RECREATIONAL VEHICLE SERVICE CAMPAIGN

SERVICE ADVISORY 23-438

SERVICE ADVISORY # 23-438

Hideout 186SS and Springdale 1860SS Slide Floor

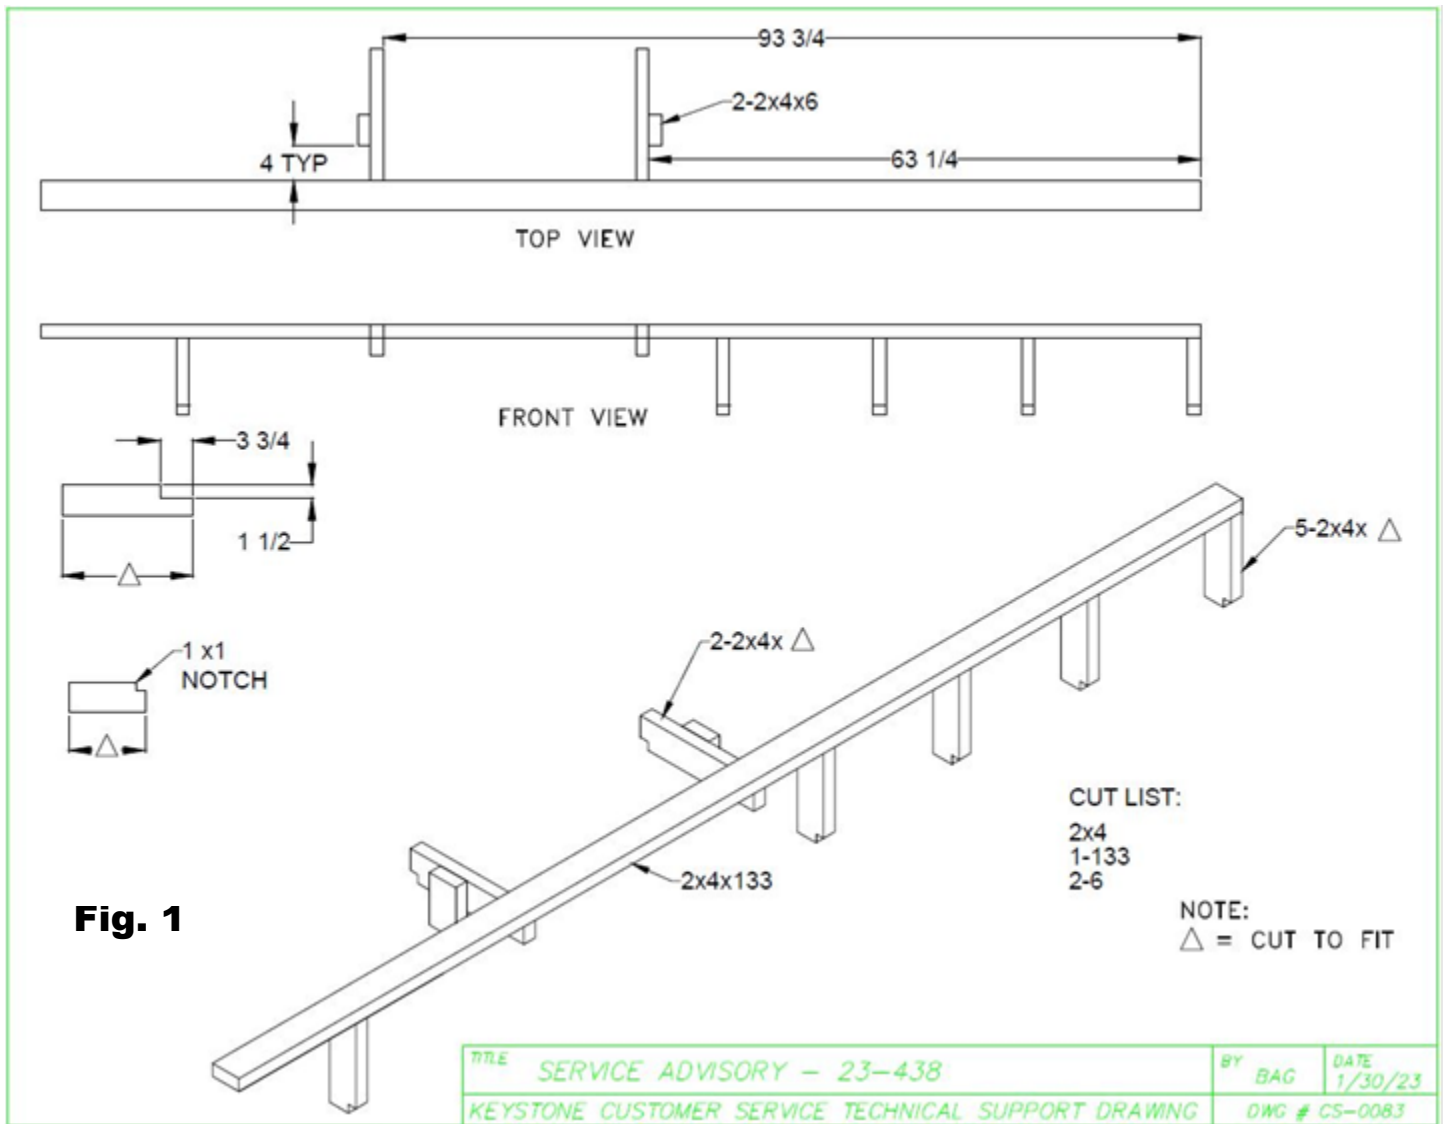
Remove the wood cleat from the top of the cabinet front and discard it. Assemble the 2"x 4" wood support frame as shown in the print. See Figure 1. Once assembled the wood support frame work should be flush with or slightly above the cabinet face. Set the wood support frame in place over the wheel well. Attach the wood support frame to the wheel well using a piece of 2"x 4" that is cut to approximately 6 inches on each end of the wheel well.
